City of Calgary – Mobility Street Lighting Division
MEMO: Street Light Design Revisions & Best Practices
April 2023

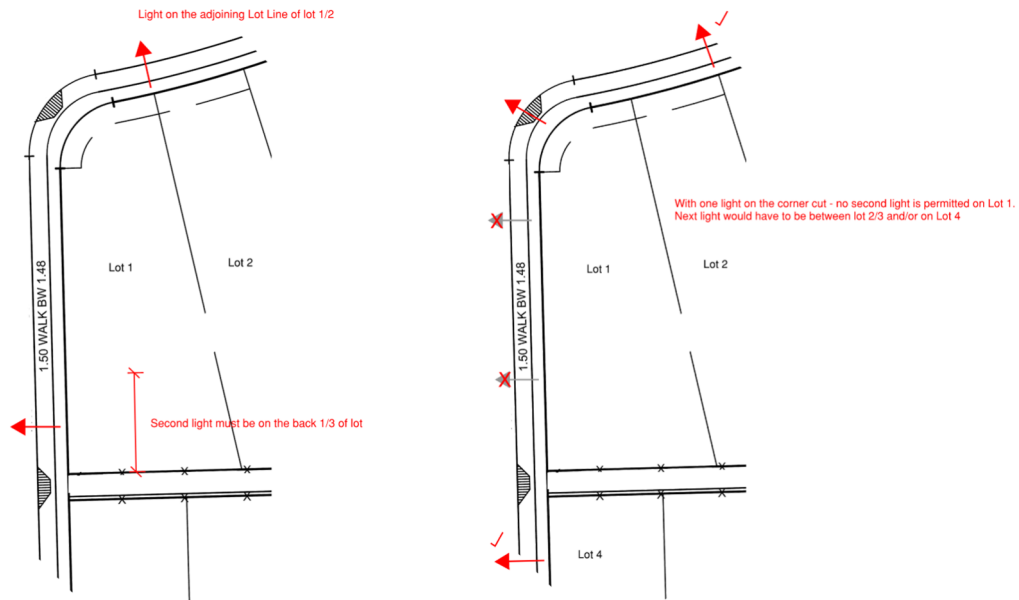
3. Adjacent existing phases must be clearly marked with the subdivision name and phase number. Add map number to this note if known.

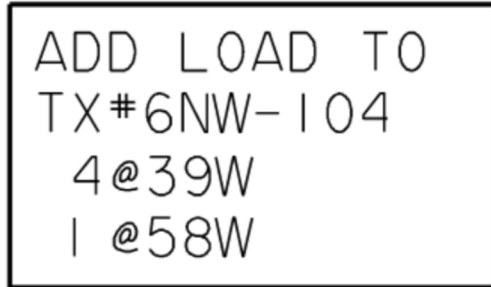
3. Add Load and Remove Load notes are to be placed beside every transformer on the design (or manhole in the downtown network) where lights will be added or removed on a circuit. The note should clearly indicate the transformer or manhole number. Do not provide the aggregate total, each wattage of light is to be specified individually.

ADD LOAD TO
TX#6NW-104
4@39W
1 @58W

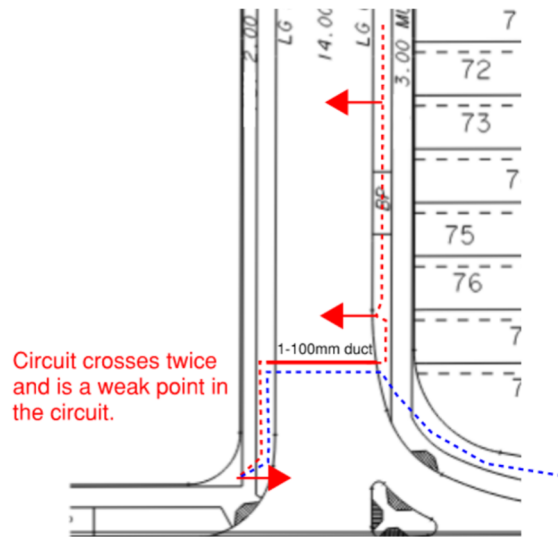
4. Each street light circuit is not to exceed 12 **davits**. Double davits can be included in the 12 davit maximum (i.e. 24 lights on 12 davits) as long as the design conforms to voltage drop regulations.
5. Design submissions are to include a voltage drop summary table and a copy of the design with each circuit highlighted to show the longest route and the voltage drop of that branch.
6. It is expected that a site visit will be performed to confirm existing conditions and circuitry in the field before completing a design.
7. Street names must be labelled for all streets located within the construction boundary.
8. Remove the deep utilities on the design pdf when submitting for review and approval. If the deeps are important for the construction contractor, provide two copies for review: one showing the deep utilities and one with this layer turned off.

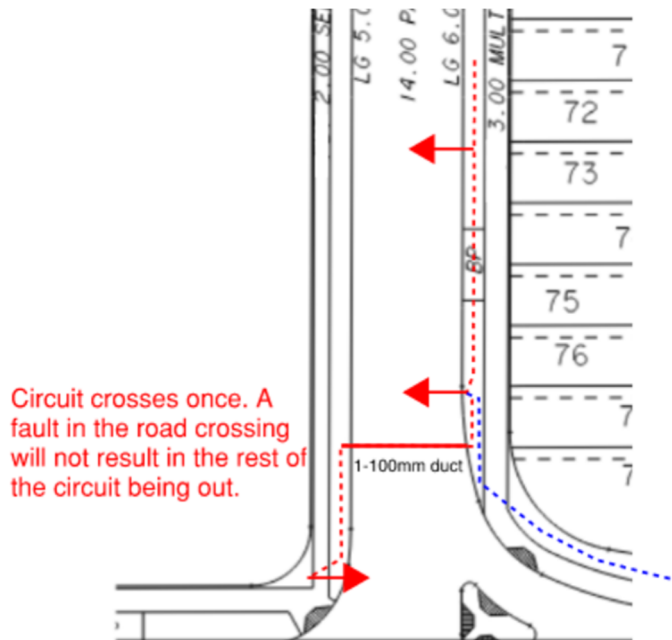
9. Effort should be made to design the branch circuitry so that it does not cross the road twice (“double back” or “in and out”) in the middle of a circuit.

The crossing is a weak point and should be a separate branch so that a fault in the road crossing does not result in the rest of the circuit being out. A road crossing to feed a single light should be placed at the end of a branch.
